UNITED STATES PATENT AND TRADEMARK OFFICE

10/072,032

Office Action Summary

DETAILED ACTION

FIG. 1.

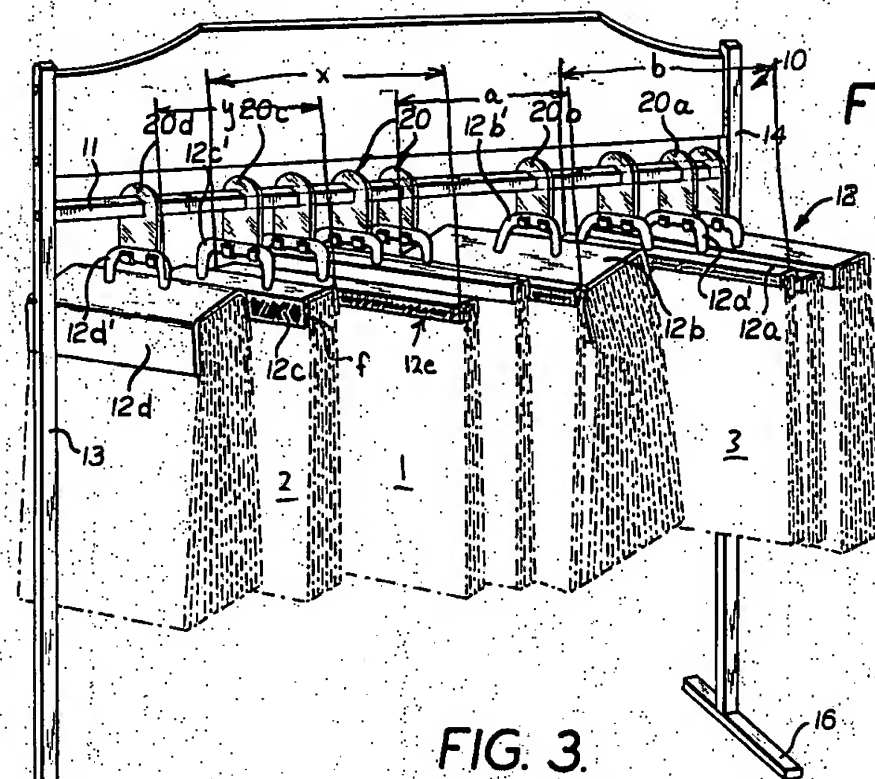
Howard '852 discloses a display device (see attached red-marked photocopy of Figure 1) comprising a rack (including elements 11 and 13-16) having at least one support member (at 11) having a body portion (13-16) extending therefrom; a first array of at least two display panels (12c and 12e) mounted (through elements 12c and 12e, respectively) to a first side, i.e., left side of Figure 1, of the rack whereby one of the display panels (12e) is an underlying panel having a first display surface (red - at 12e) with a sample of a first displayed floor covering material (1), i.e., carpet, mounted thereon and the first display surface (12e) having a first width (x) and a first height; another one of the display panels (12c) in the first array defining an overlying panel having a second width (y) and a second height and an inner edge (at 20c) mounted to the rack and a free edge (f) distal the inner edge whereby the second width (y) is sufficiently less than the first width (x) such that at least a portion of the floor covering material (1) is visible beyond the

free edge (f) of the overlying panel (12c) with the overlying panel (12c) overlying the underlying panel (12e); the display device further comprising a second array of display panels (red, below elements 12a and 12b) mounted to a second side, i.e., the right side of Figure 1, of the rack; one of the panels (on 12a) in the second array defining a second underlying panel having a display surface with a sample of a second displayed floor covering material (3) mounted thereon whereby the second display surface (on 12a) has a third width (b) and a third height; another one (on 12b) on the panels of the second array defining a second overlying panel having a fourth width (a) and a fourth height and an inner edge (at 20b) mounted to the rack; the fourth width (a) being sufficiently less than the third width (b) such that at least a portion of the second material (3) is visible with the second panel (on 12b) overlying the second panel (on 12a).

The claims differ from Howard '852 in requiring the panels tot be *pivotally* mounted to the rack.
